SUBMITTAL SUMMARY REPORT 33483

PLAN NAME: BELLEVIEW CIRCLE K	LOCATION: 13210 S US HWY 301 BELLEVIEW,
APPLICATION DATE: 10/01/2025	PARCEL: 45415-000-00
DESCRIPTION:

PLN 33483
CIRCLE K

Development Review Committee Waiver Request Form

SHEET NUMBER
4

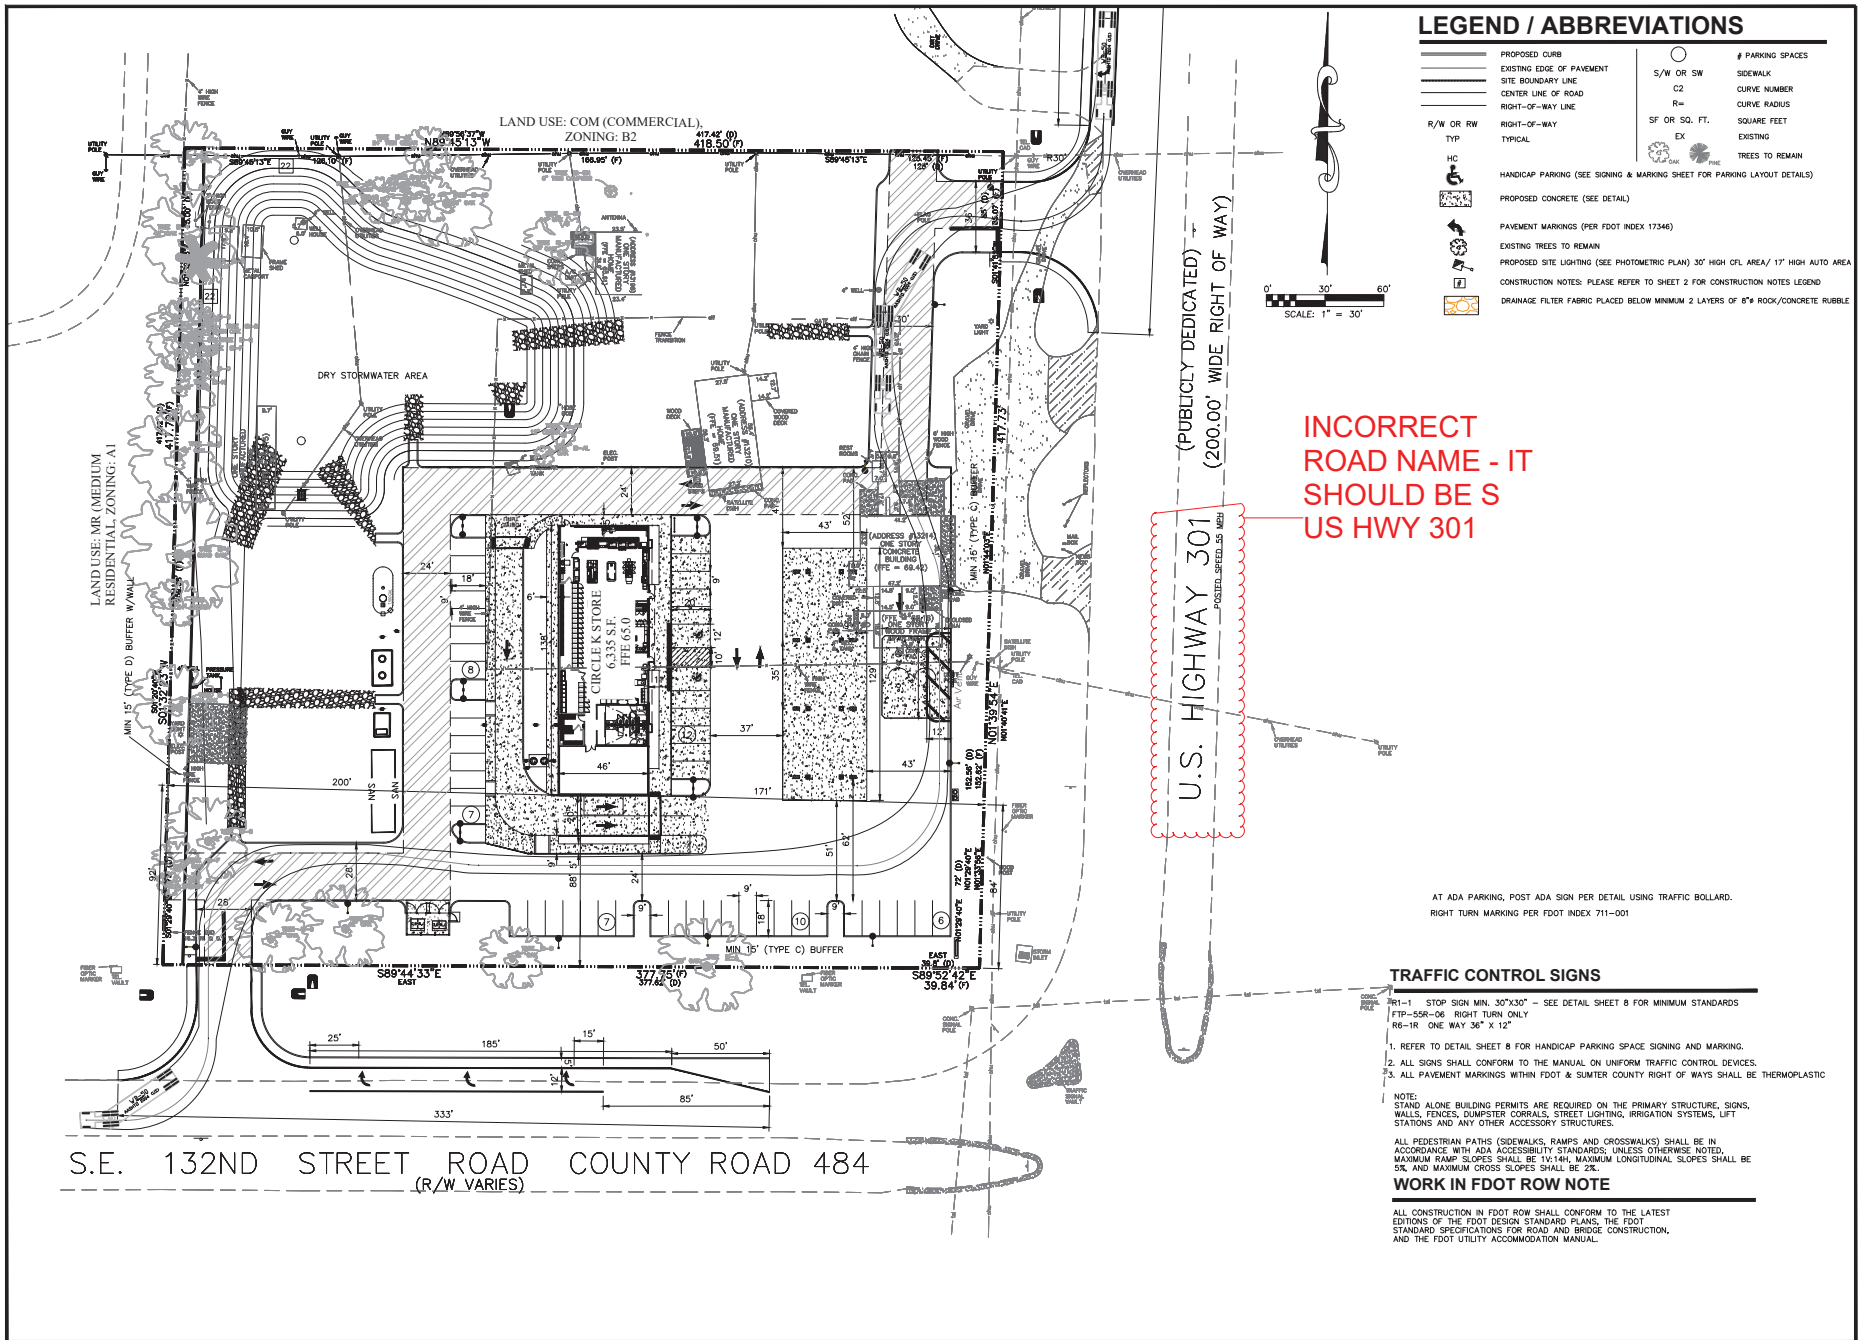
<i>Corrections</i>	Additional 911 Comments (Not Resolved) - Sheets 4, 4T, and 5 have S US HWY 301 labeled incorrectly as US HWY 301. Sheet L1 has SE 132nd Street Rd incorrectly labeled as County Road 484 and S US HWY 301 incorrectly labeled as US HWY 301. Sheets L1, ECP, and MOT 1 - Title Bar have Circle K @ NWC of US301 & CR484 Belleview but it should be Circle K at NWC S US HWY 301 & SE 132nd Street Rd.			
Environmental Health (Plans) (Environmental Health)	Evan Searcy	03/19/2026	03/13/2026	Approved
Fire Marshal (Plans) (Fire)	Anthony Marino	03/19/2026	03/12/2026	Approved
<i>Comments</i>	Fire Review has been approved a hydrant to be installed			
Growth Services Planning & Zoning (DR) (GS Planning and Zoning)	Erik Kramer	03/19/2026	03/19/2026	Requires Re-submit

<i>Corrections</i>	6.11.4.B - Cross access (Not Resolved) - Corrective Action: Please fully address the previous comment. Provide a 24' wide paved public cross access easement parallel to both CR 484 and US 301 as shown on the markups. The easement must be paved to each property line. The easement must be in the form established by the County. The template for the easement can be obtained from the Development Review Office at DevelopmentReview@marionfl.org or 352-671-8686. The easement must be executed and returned back to the Development Review Office along with the recording fees prior to final plan approval. - 6.11.4.B - Cross access: Provide a 24' wide paved cross access easement as specified in 6.11.4.B			
<i>Corrections</i>	6.11.9.C - Pavement marking (Not Resolved) - Corrective Action: Label the pavement markings for the turn lane on CR 484. All markings shall be thermoplastic. - 6.11.9.C - Pavement marking: Provide pavement markings as required in Section 6.11.9.C.

<i>Corrections</i>	6.11.9.B - Traffic signs (Not Resolved) - Corrective Action: Place a right turn only sign underneath the stop signs at the driveways. Also place a one-way sign in the medians in front of the driveways. - 6.11.9.B - Traffic signs: Provide traffic signs as required in Section 6.11.9.B.			
<i>Comments</i>	Please address previous comments			
Utilities (OCE Plans) (Utilities)	Heather Proctor	03/19/2026	03/19/2026	Requires Re-submit
<i>Corrections</i>	6.14.5.A(2) - Proposed mains & connections shown (Not Resolved) - Corrective Action: Ensure proposed new mains are called out; include profile views. - 6.14.5.A(2) - Proposed mains & connections shown: Proposed mains shall be marked as private or public (MCU); points of demarcation shall be called out as necessary to identify changes in ownership. Shall include profile views unless otherwise noted.			
<i>Corrections</i>	6.14.2.A(1) - Letter from utility provider (Not Resolved) - Corrective Action: The parcel is located within the City of Belleview Utilities service area. A letter from the City of Belleview stating utility service availability and connection requirements must be submitted prior to building permit issuance. Because the parcel is within the City of Belleview Utilities service area but outside the City limits, connection distance requirements will be determined in accordance with the Marion County Land Development Code if utilities are not immediately available.
